Access Compliance Report

Public Rights-of-Way

(Pedestrian Signals)

Intersection ID: N/A	Main Street:	Cross Street: N/A	Location: N/A
ADA ID: F8BE3B718CF5	Signal Type: One Push Button-Non APS	Overall Compliance: No	Severity Score: BTN 1: N/A BTN 2: N/A No BTN: N/A
Codes/Mitigation Info/Possible Solution		Field Measurements/Component Compliance

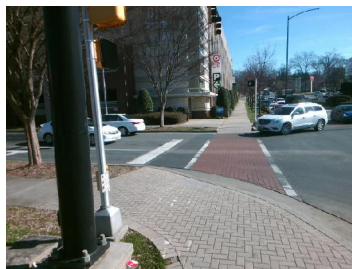
Possible Solutions: Replace Signal Push Button With APS Button on New Post. Remove & Relocate Sign.

PROW/ADA: TMUTCD 4e.08, R406.2, R404.7.3
